Flight manual DG-800S

0.1 Record of revisions

Rev. No.	Affected Pages/ section	Description	Issue Date	LBA Approval Date	Inserted Date Signature
1	0.5, 9.1-9.3	TN 384/5 Winglets at the 18 m wingtips	June 98	22.7.1998	
2	0.4, 7.5	TN 384/6 Parking brake combined with an airbrake securing device (Piggott-hook)	Dec, 2000	7.02.2001	
3	0.3, 0.4, 2.5, 4.11, 4.15, 5.3, 6.9	TN 384/8 manual revision	Nov. 2001	17.12.01	
4	0.5, 9.1, 9.2, 9.4-9.6	TN 384/9 emergency bail out aid NOAH	January 2003		
5	0.1, 0.5, 9.4	TN DG-G-11 NOAH Improvements	May2015

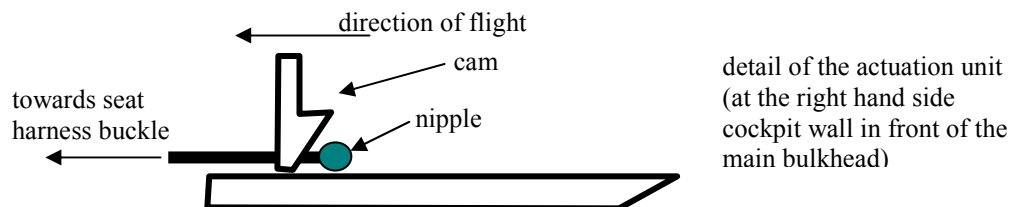
Check especially if the nipple of the cable which opens the seat harness buckle is positioned aft of the cam of the actuation unit see sketch:
